GTR No. 9 – Draft proposal for Amendment 2

Note: The text reproduced below was prepared by the chairman and vice-chairman of the informal working group on the global technical regulation No. 9 (Pedestrian safety)-Phase 2 proposing the use of a flexible pedestrian lower legform impactor in the global technical regulation No. 9 (pedestrian safety) - Phase 2. The modifications to the current text of gtr No. 9 on pedestrian safety are marked in bold for new or strikethrough for deleted characters. Text in square brackets is still under discussion and consideration of the informal group.

I. Proposal

Figure 12 Flexible lower legform impactor; Dimensions and C.G. locations of femur, knee joint and tibia (Side view)

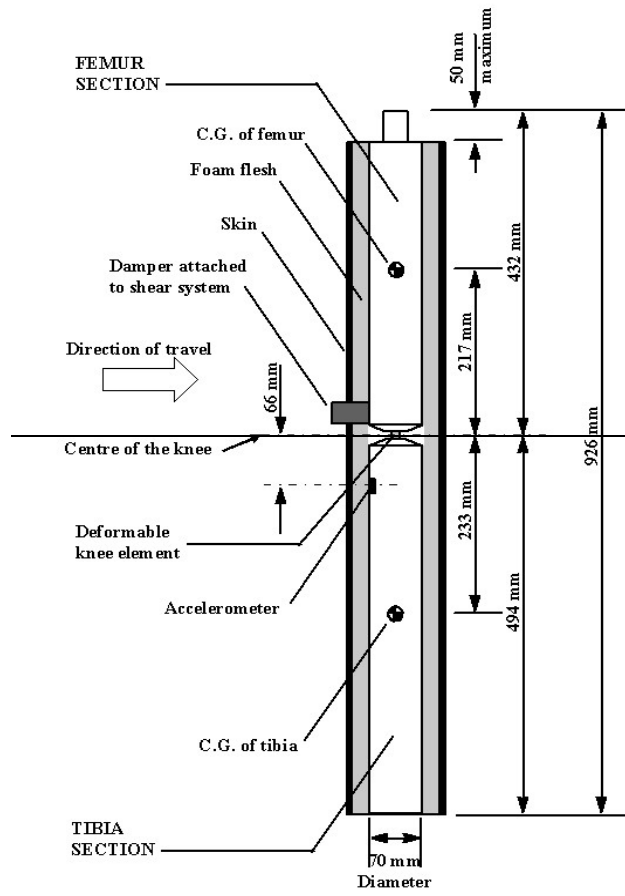
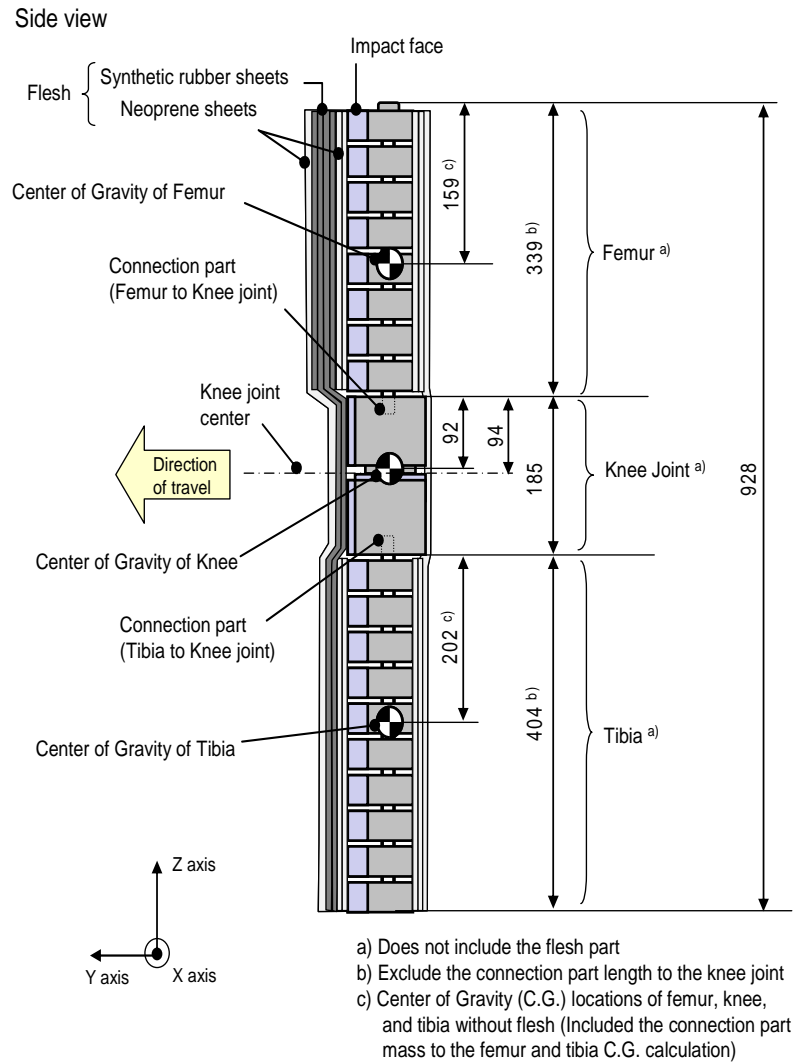
The flexible lower legform impactor shall consist of flesh, flexible long bone segments (representing femur and tibia), and a knee joint as shown in Figure 12.

Brackets, pulleys, protectors, connection parts, etc. attached to the impactor for the purpose of launching and/or protecting may extend beyond the dimensions shown in Figure 12 and Figure 13.

The centre of gravity of the femur and tibia without flesh, including the connection part to the knee joint, shall be 159 ± 8 mm and 202 ± 10 mm respectively from the top, but not including the connection part to the knee joint, of each part as shown in Figure 12. The centre of gravity of the knee shall be 92 ± 5 mm from the top of the knee joint as shown in Figure 12.

Delete Figures 12, to read:

Insert new Figures 12 to 16, to read:

Figure 13 flexible lower legform impactor; femur, tibia, and knee dimensions (Top view)

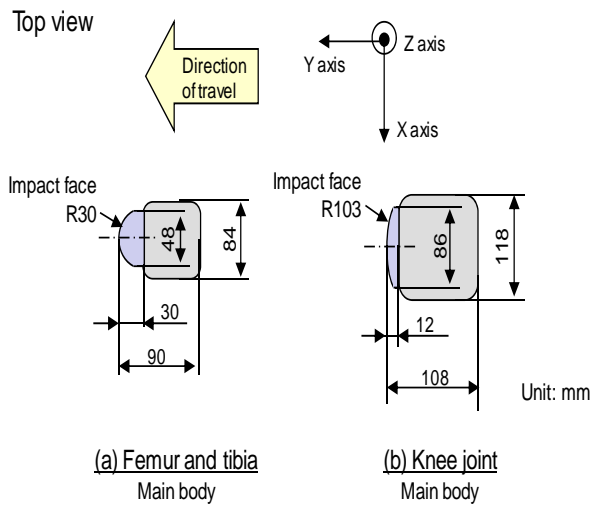
6.3.1.1.1. **The cross-sectional shape perpendicular to the Z-axis of the femur and tibia main bodies shall be 90 ± 2 mm in width along the Y-axis, and 84 ± 1 mm in width along the X-axis as shown in Figure 13 (a). The impact face shall be 30 ± 1 mm in radius, 30 ± 1 mm in width along the Y-axis, and 48 ± 1 mm in width along the X-axis as shown in Figure 13 (a).**

- 6.3.1.1.2. **The cross-sectional shape perpendicular to the Z-axis of the knee joint shall be 108 ± 2 mm in width along the Y-axis, and 118 ± 1 mm in width along the X-axis as shown in Figure 13 (b). The impact face shall be 103 ± 1 mm in radius, 12 ± 1 mm in width along the Y-axis, and 86 ± 1 mm in width along the X axis as shown in Figure 13 (b).**

Figure 14 Flexible lower legform impactor; flesh dimensions

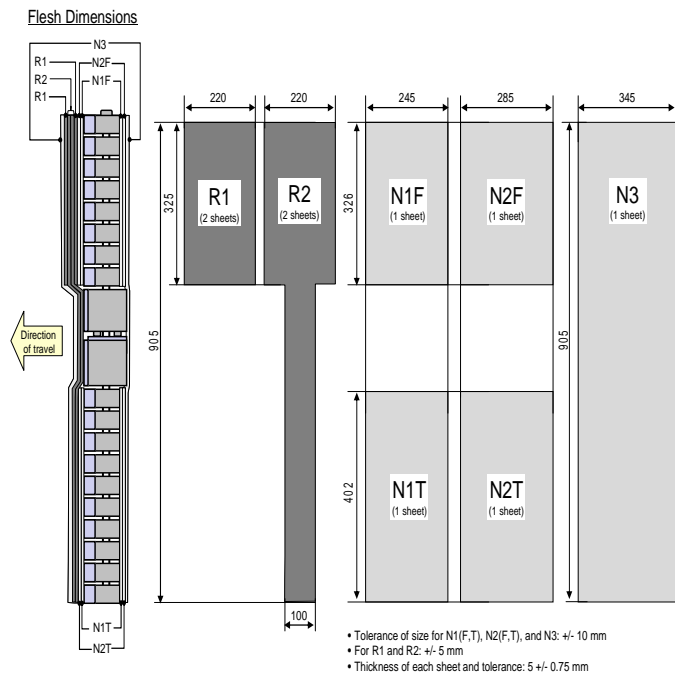
- 6.3.1.1.4. **For each test, the impactor (femur, knee joint, and tibia) shall be covered by flesh composed of synthetic rubber sheets (R1, R2) and neoprene sheets (N1F, N2F, N1T, N2T, N3) as shown in Figure 14. The sheets are required to have a compression characteristic as shown in Figure 15. The compression characteristic shall be checked using the same batch of sheets as those used for the impactor flesh. The size of the sheets shall be within the requirements described in Figure 15.**

Figure 15 Flexible lower legform impactor; flesh compression characteristics

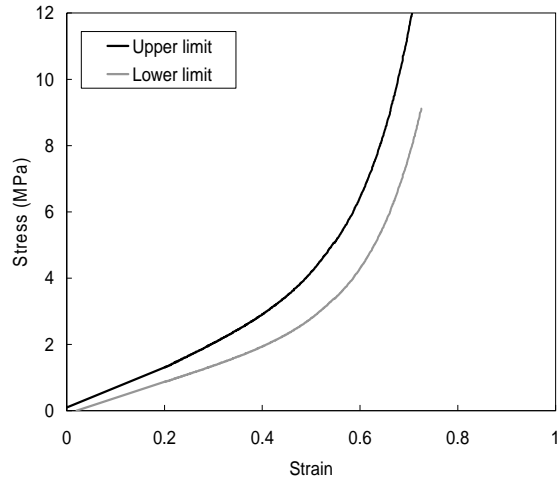
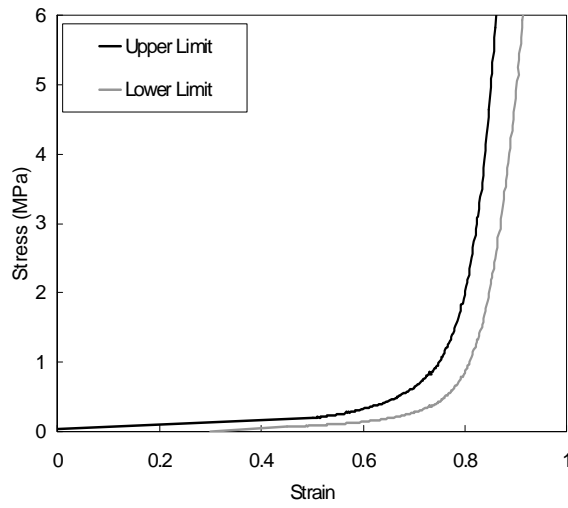
8.1.1.5. **The edges of the knee joint, not bending parts, shall be mounted to the support rig firmly as shown in Figure 26. The Y-axis of the impactor shall be parallel to the loading axis within $180 \pm 2^\circ$. In order to avoid friction errors, roller plates shall be set underneath the support rigs. To avoid impactor damage, a neoprene sheet shall be set underneath the loading ram and the impactor face of the knee joint which is described in the Figure 13 shall be removed. The neoprene sheet used in this test shall have compression characteristics as shown in Figure 15.**

Figure 16 flexible lower legform impactor; instrument locations

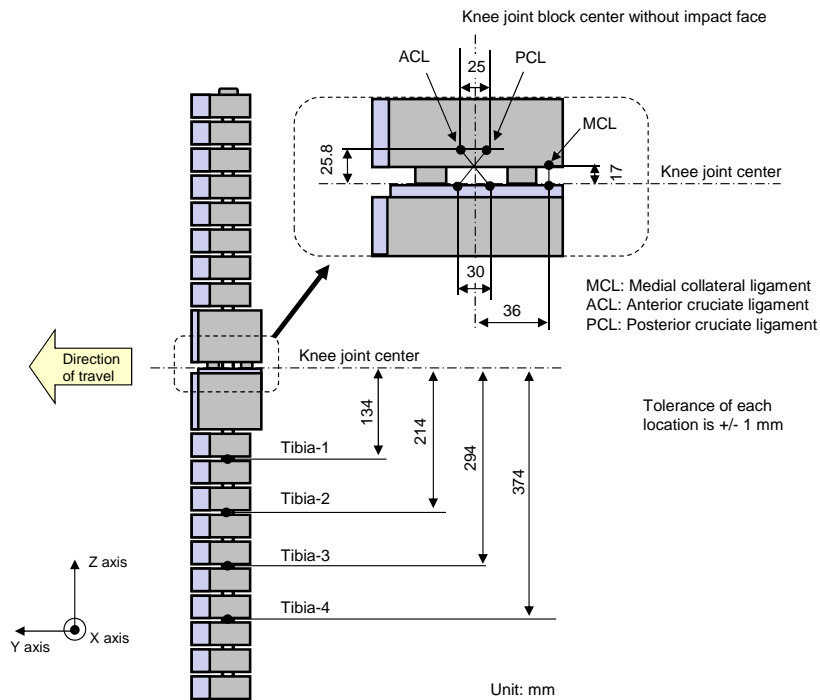
- 6.3.1.1.6.1. **Four transducers shall be installed in the tibia to measure bending moments applied to the tibia. The sensing locations of each of the transducers are as follows: tibia-1: 134 ± 1 mm, tibia-2: 214 ± 1 mm, tibia-3: 294 ± 1 mm and tibia-4: 374 ± 1 mm below the knee joint centre respectively as shown in Figure 16. The measurement axis of each transducer shall be the X-axis of the impactor.**

- 6.3.1.1.6.2. **Three transducers shall be installed in the knee joint to measure elongations of the medial collateral ligament (MCL), anterior cruciate ligament (ACL), and posterior cruciate ligament (PCL). The measurement locations of each transducer are shown in Figure 16. The measurement locations shall be within ± 4 mm along the X-axis from the knee joint centre.**

Figure 21 Flexible lower legform impactor Lower legform to bumper tests for complete vehicle in normal ride attitude (left) and for cut-body mounted on supports (right) (see paragraph 7.1.1.3.) "

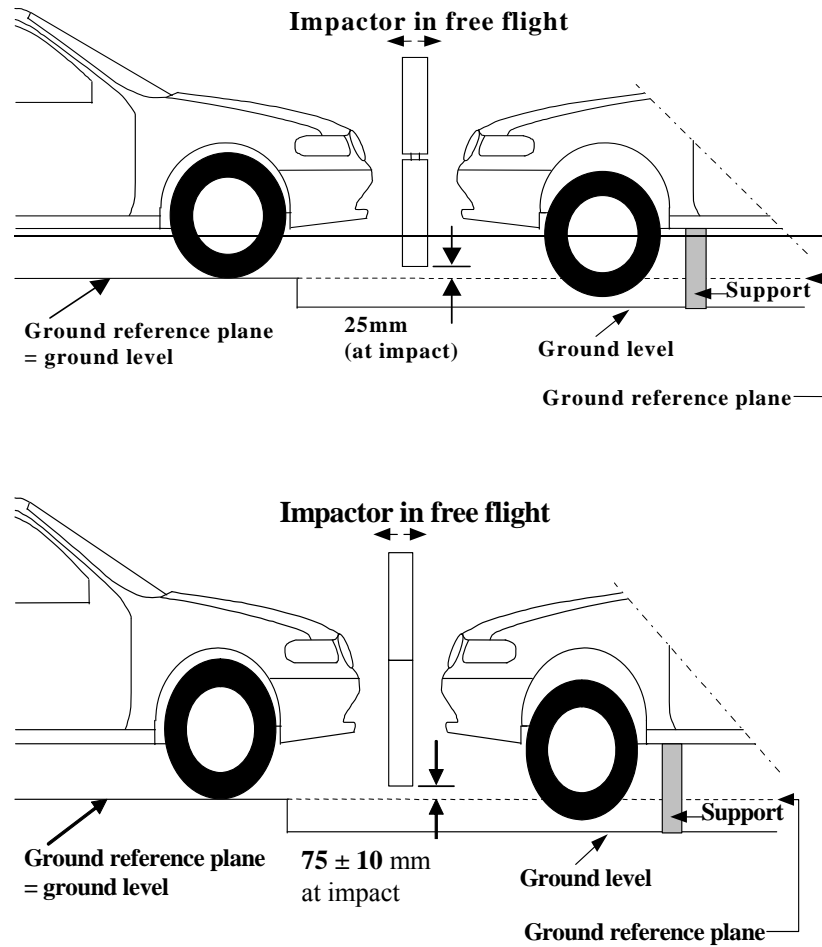
7.1.1.3. **The bottom of the impactor shall be at 75 mm above ground reference plane at the time of first contact with the bumper (see Figure 21), with a ± 10 mm tolerance. When setting the height of the propulsion system, an allowance must be made for the influence of gravity during the period of free flight of the impactor.**

Figures 17(former), renumber as Figure 21 and amend to read:

Figure 17 (former): renumbering and replaced by flexible lower legform impactor requirements.

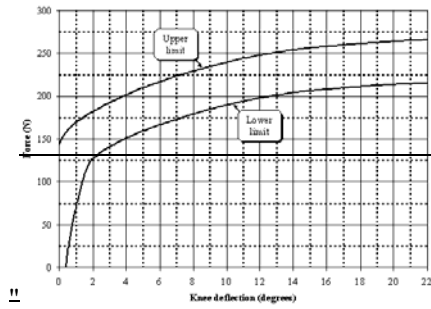
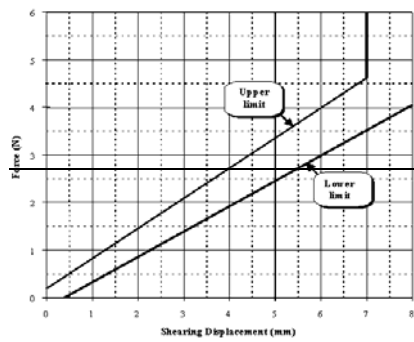
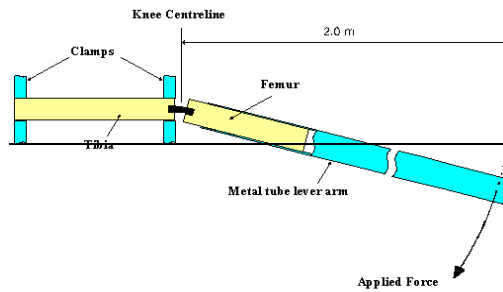
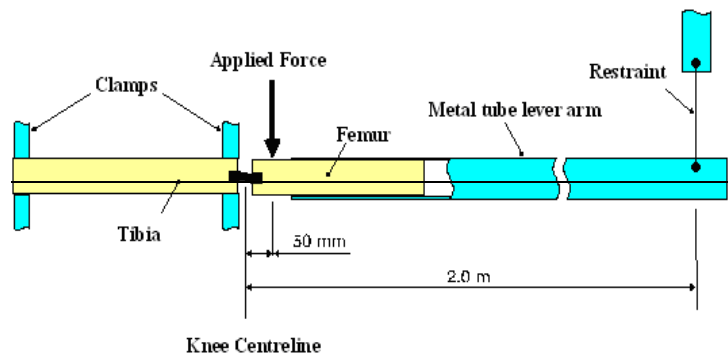
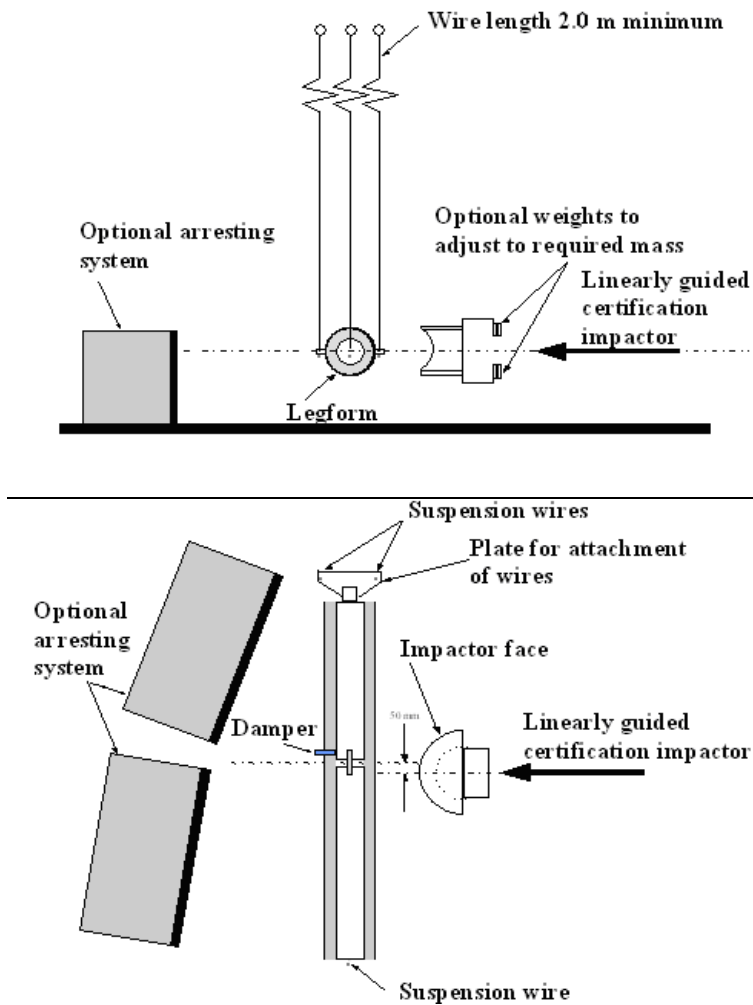
Delete Figures 18 to Figure 21, to read:

Delete Figures 18 to Figure 21 : delete figure for EEVC lower legform impactor.

Figure 22 Flexible lower legform impactor requirement corridor of femur and tibia in static certification test
(see paragraph 8.1.1.2.)

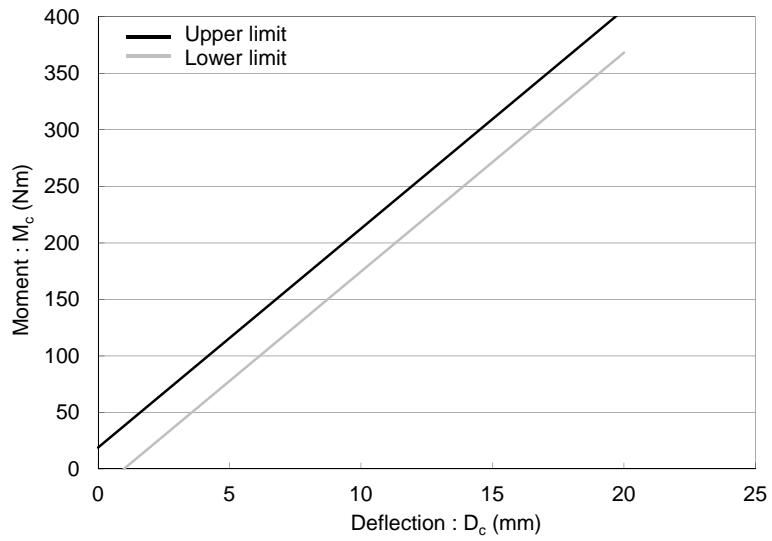
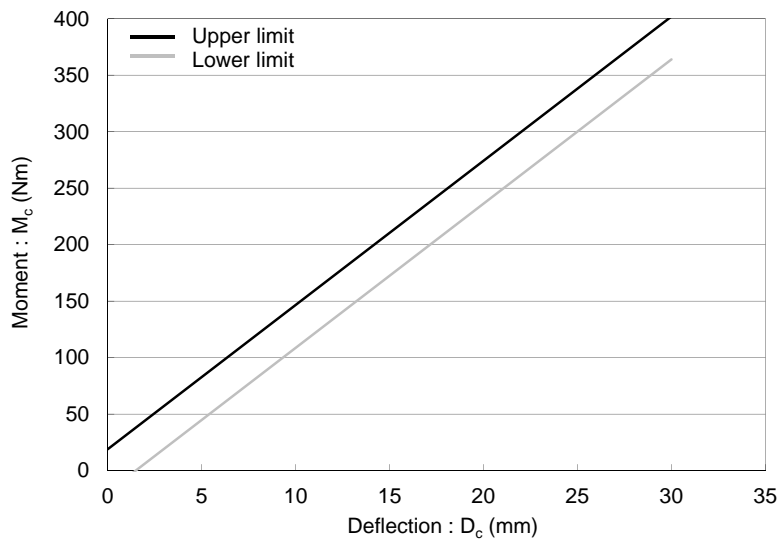
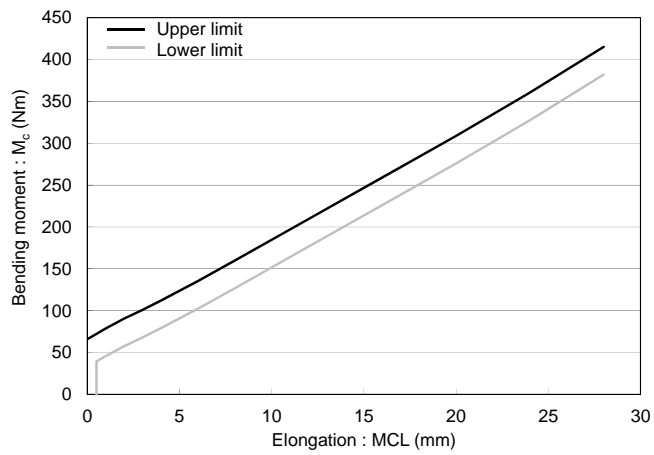
8.1.1.2. **When the femur and tibia of the impactor are loaded in bending in accordance with paragraph 8.1.1.4., the applied moment and generated deflection at the centre of the femur and tibia (M_c and D_c) shall be within the corridors shown in Figure 22.**

Figure 23 Flexible lower legform impactor requirement corridors for knee joint in static certification test (see paragraph 8.1.1.3.)

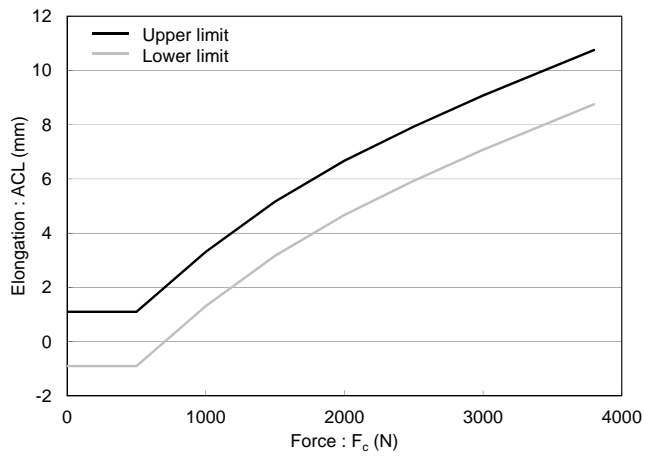
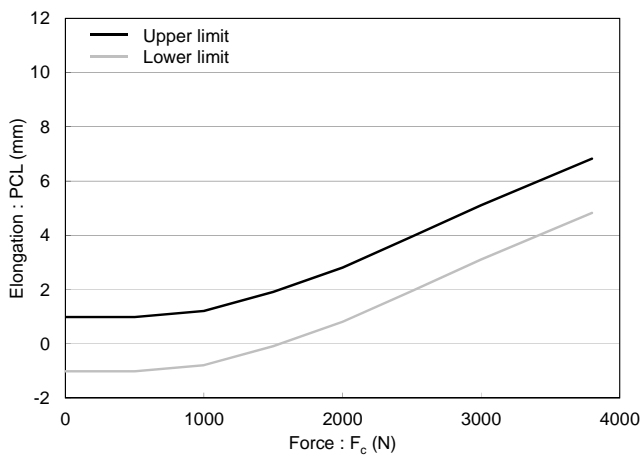
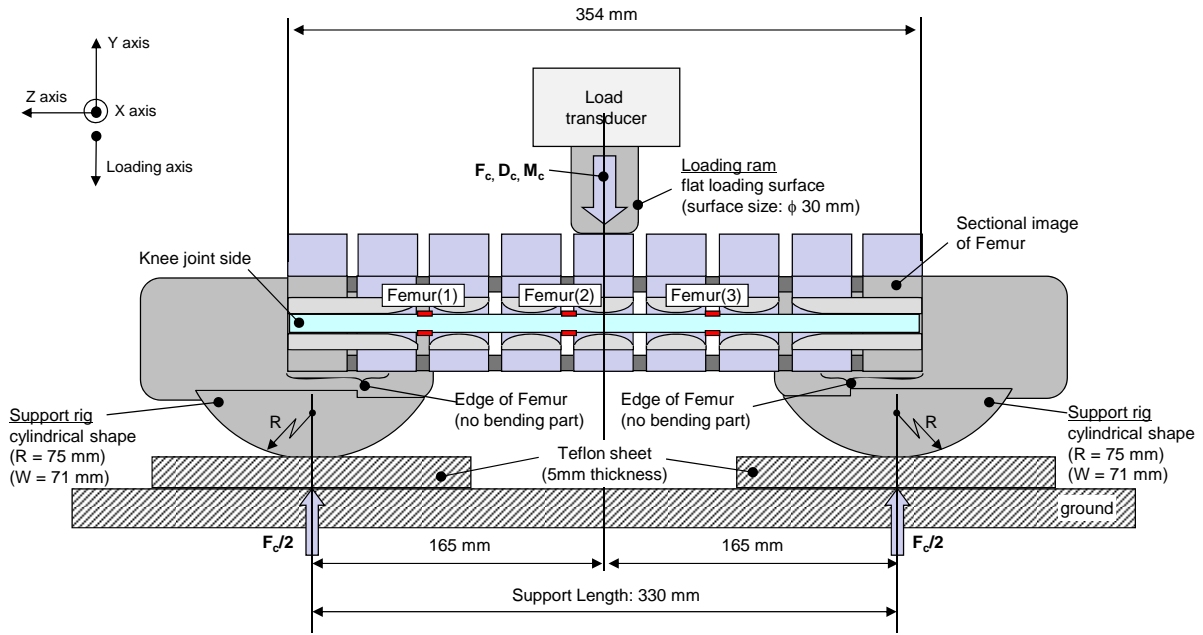
8.1.1.3. **When the knee joint of the impactor is loaded in bending in accordance with paragraph 8.1.1.5., the MCL, ACL, and PCL elongations and applied bending moment or force at the centre of the knee joint (M_c or F_c) shall be within the corridors shown in Figure 23.**

Figure 24 Flexible lower legform impactor test set-up for femur in static certification tests

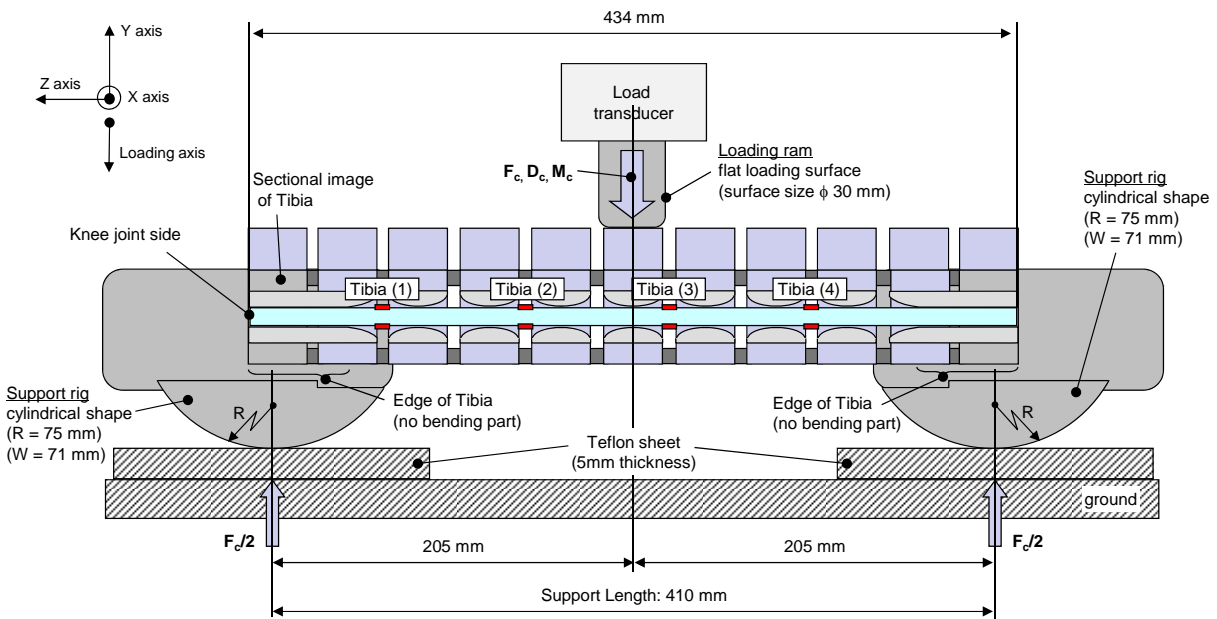
8.1.1.4. **The edges of the femur and tibia, not bending parts, shall be mounted to the support rig firmly as shown in Figure 24 and Figure 25. The Y-axis of the impactor shall be parallel to the loading axis within $180 \pm 2^\circ$ tolerance. In order to avoid friction errors, roller plates shall be set underneath the support rigs.**
